**GM SERVICE AND PARTS OPERATIONS  
DCS1394  
URGENT - DISTRIBUTE IMMEDIATELY**

SUBJECT: 05014 / Product Safety Recall  
Ignition Relay Contamination

MODELS: 2004 Buick Rendezvous  
2004 Pontiac Aztek

# Recall Bulletin

1406268

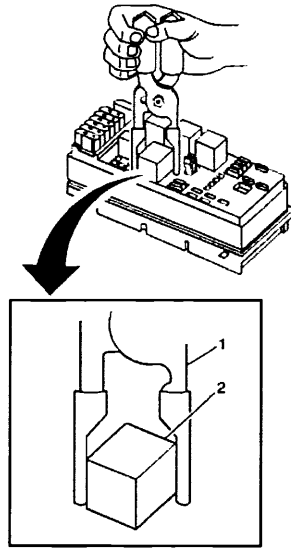
2. Locate the relay for Ignition-1 (60).
